NOTICE OF FILING

**REPORT ON THE STATUS OF CORRECTIVE ACTIONS  
FIRST EXERCISE AND DRILL CYCLE  
1988 TO 1994  
OF THE STATES OF MAINE AND NEW HAMPSHIRE  
AND NEW HAMPSHIRE YANKEE'S OFFSITE RESPONSE ORGANIZATION  
FOR THE SEABROOK STATION**

REVIEW AND EVALUATION OF THE STATE OF NEW HAMPSHIRE  
RADIOLOGICAL EMERGENCY RESPONSE PLAN FOR  
SEABROOK STATION

FIGURE 1 Seabrook Station Plume Exposure Emergency Planning Zone

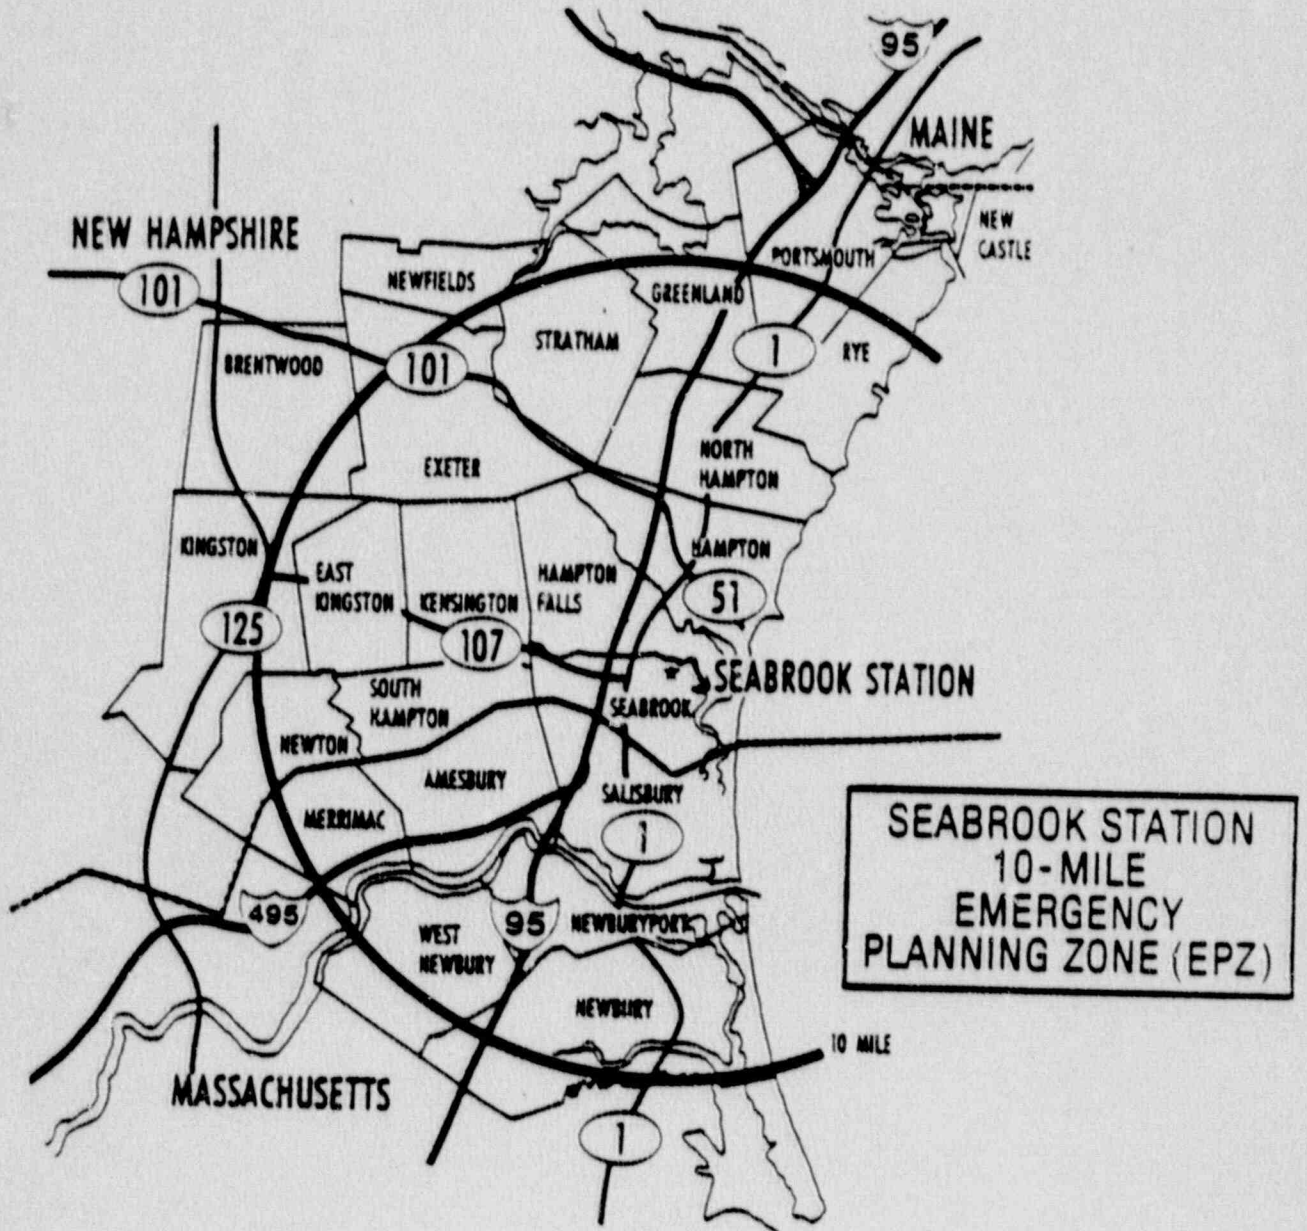
J.9 The Plan (App. C, Vol. 9) describes the New Hampshire communities within the Seabrook Station plume exposure EPZ as being within Rockingham County, New Hampshire. All land area is said to be under the jurisdiction of the following communities: Brentwood, East Kingston, Exeter, Greenland, Hampton, Hampton Falls, Kensington, Kingston, New Castle, Newfields, Newton, North Hampton, Portsmouth, Rye, Seabrook, South Hampton, and Stratham. The navigable waters of the Atlantic Ocean are under the jurisdiction of the USCG. See Figure 1 on page xvii.

FIGURE 2 Seabrook Station Ingestion Exposure Emergency Planning Zone

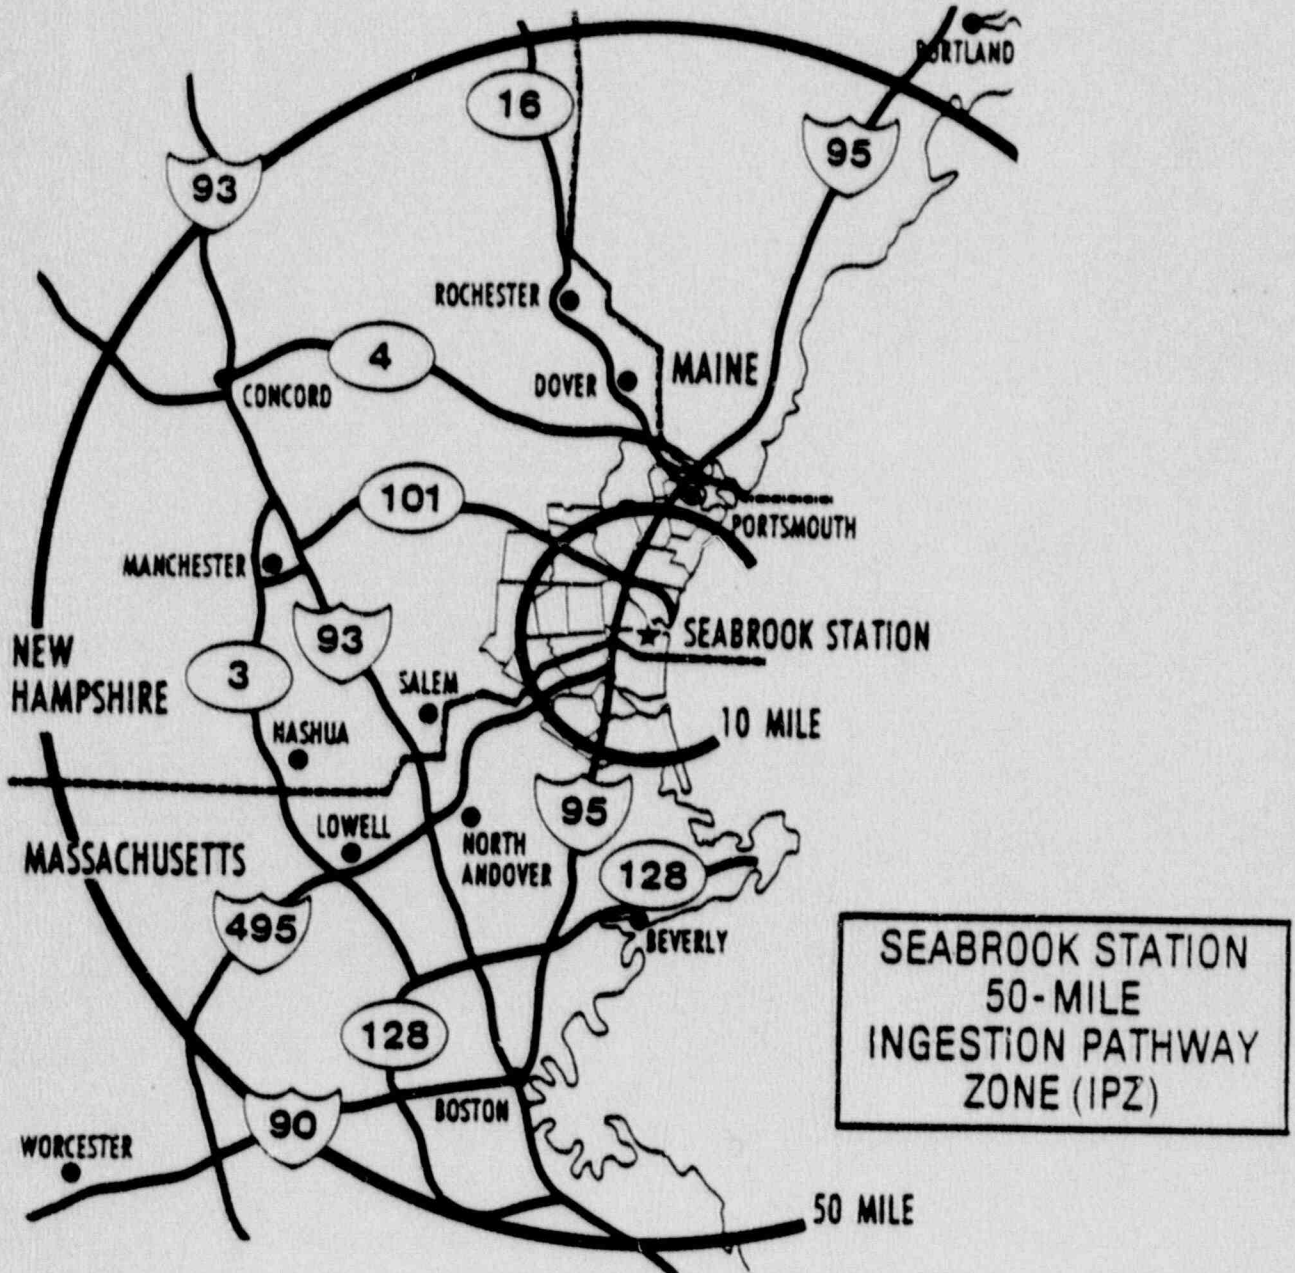
The Plan (Figure C1.1-2, Vol. 9) identifies all or portions of the following New Hampshire counties as being part of the ingestion exposure EPZ: Rockingham, Hillsborough, Merrimac, Belknap, Strafford, and Carroll. See Figure 2 on page xviii.
